Approved Section 4.55 (2) Modification Application

No: SSD 6966 MOD 1 Granted on 19 August 2021

ONE SYDNEY HARBOUR

BARANGAROO

1 Primary Facade - Balcony - Elevation
1 : 25

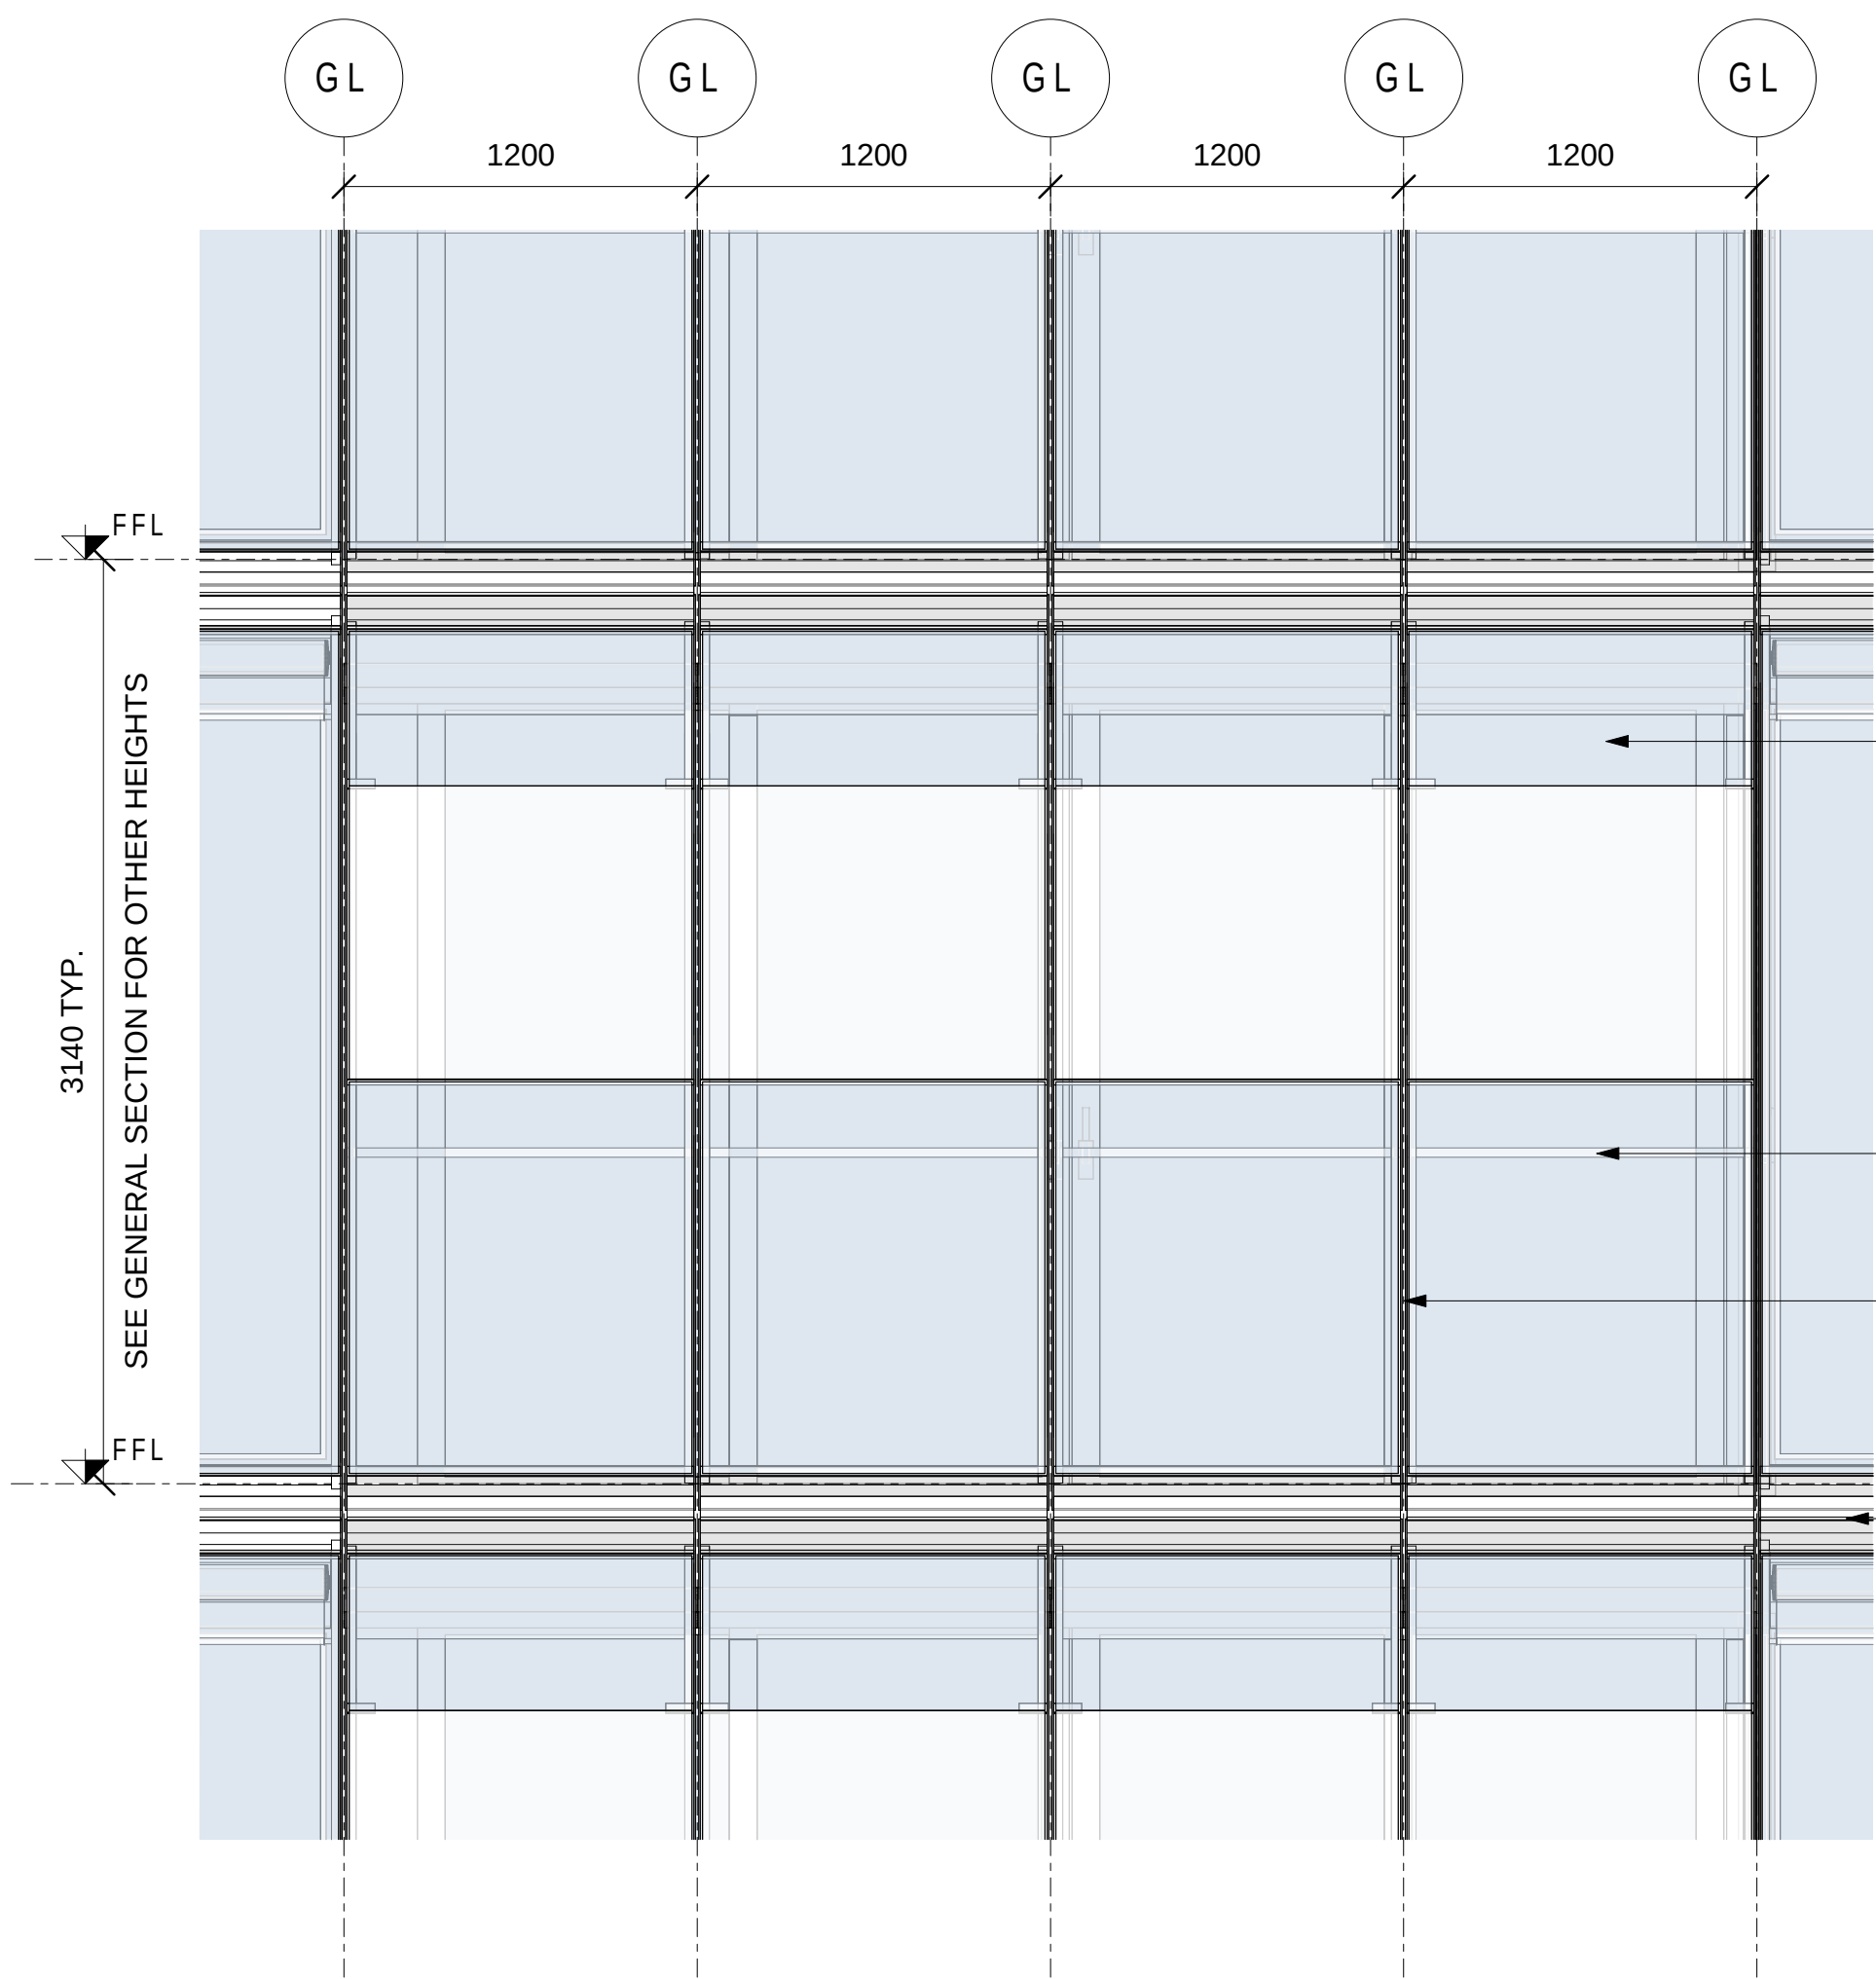
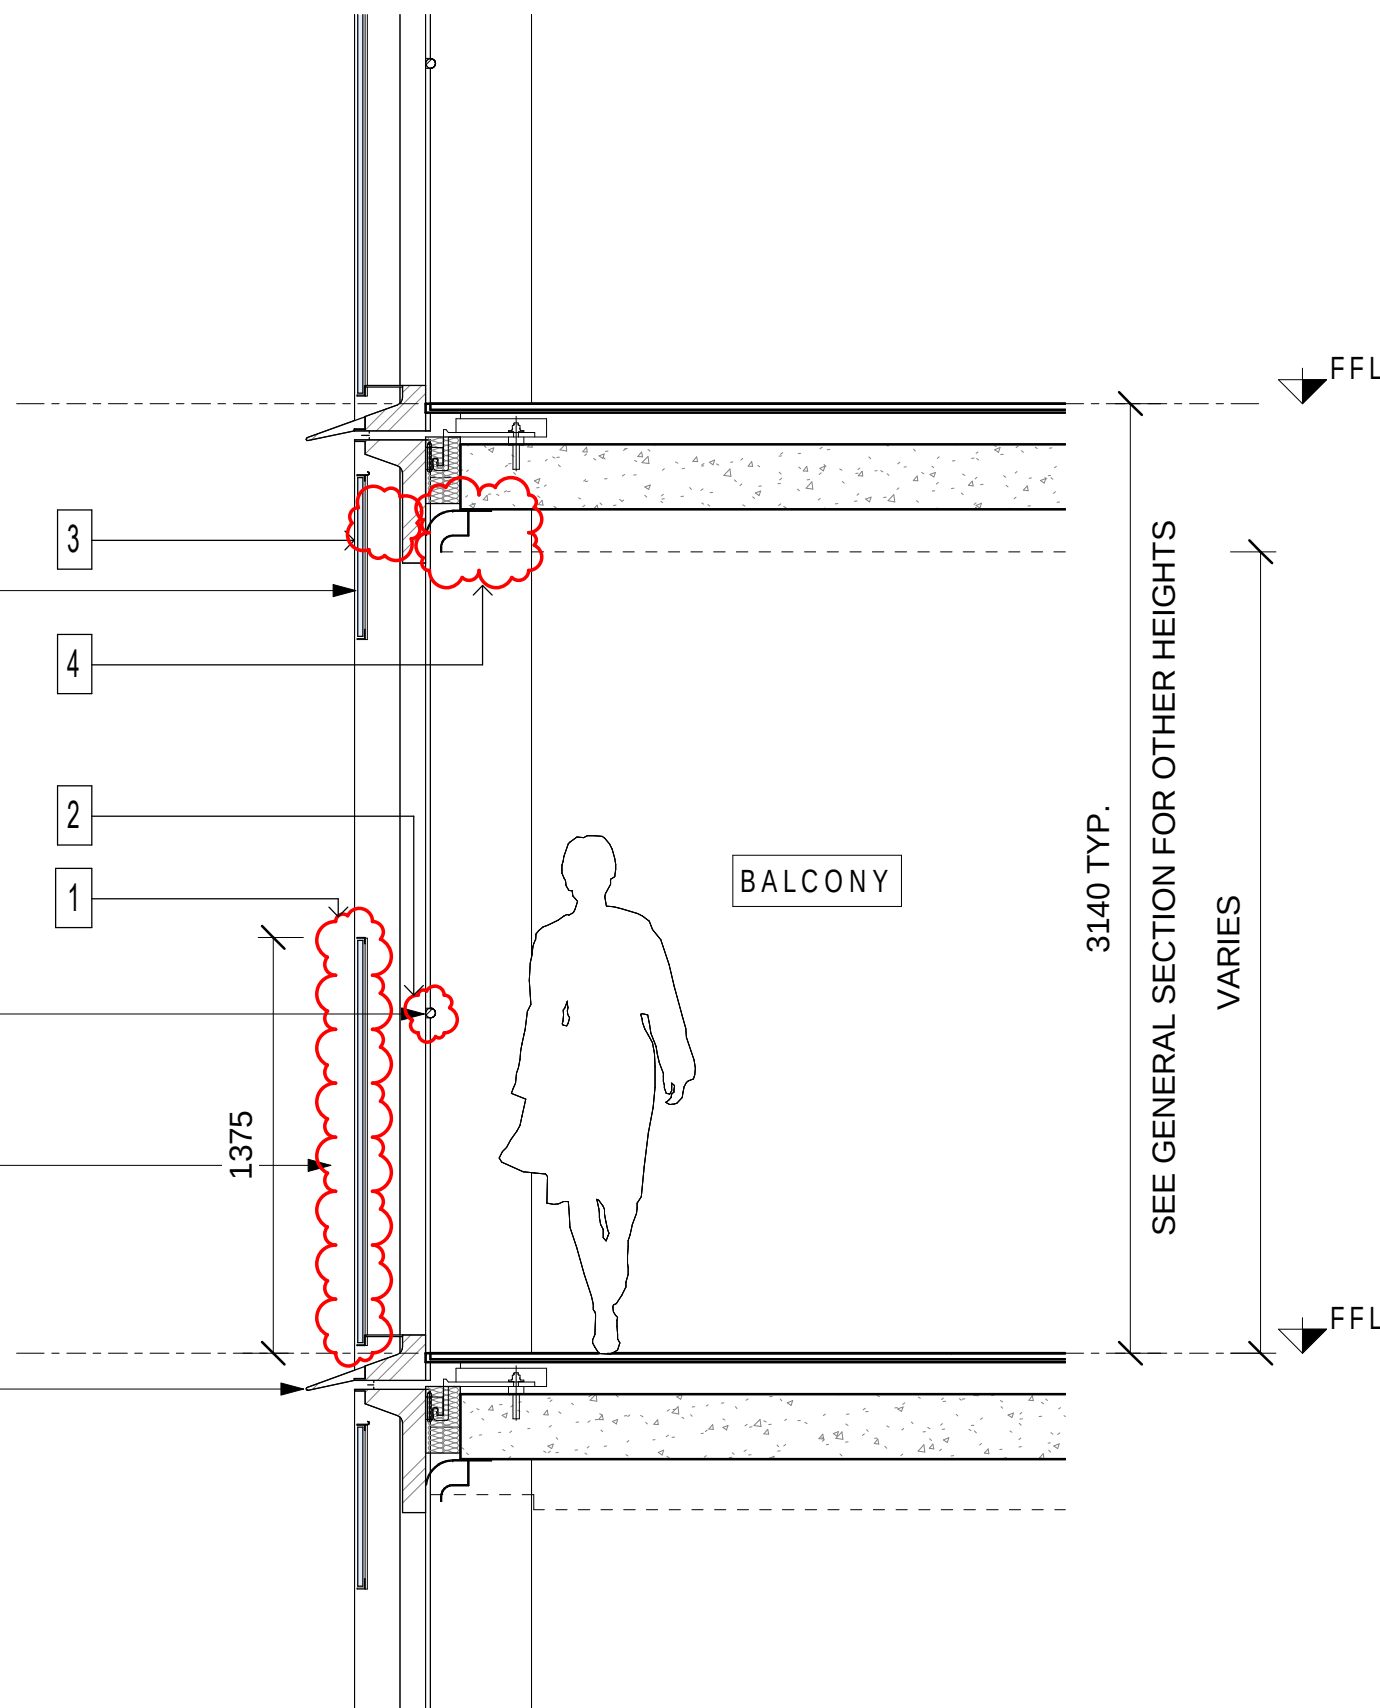
1. UPDATED BALUSTRADE HEIGHT
2. UPDATED HANDRAIL GEOMETRY
3. REMOVED BLINDS
4. UPDATED CEILING DETAIL
